A358 Taunton to Southfields Scheme Suppression of the Concerns of Community of Parishes

**Taunton to Southfields
Dualling Scheme**

**Response from
the Community
of Parishes**

A358 Dualling: Taunton to Southfields Parish Councils' Proposals for Satisfactory Connectivity Mattock's Tree Green to Southfields

Schematic Plan of Parish Proposal 8 and 11, incorporating NH's proposal for Stewley Link and Broadway Link*

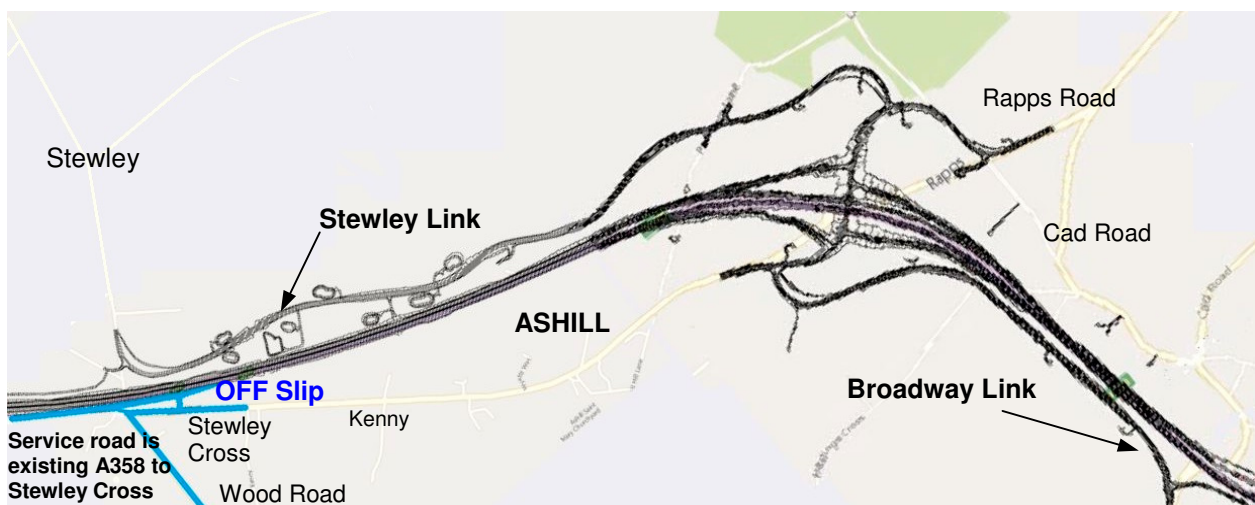
Proposal 8. The parishes, and in particular Ashill, accept the Stewley link. However, it will exacerbate severance of the Ashill parish and create difficulties for farmers working land both sides of the A358, but the parishes acknowledge the benefits to WCH users.
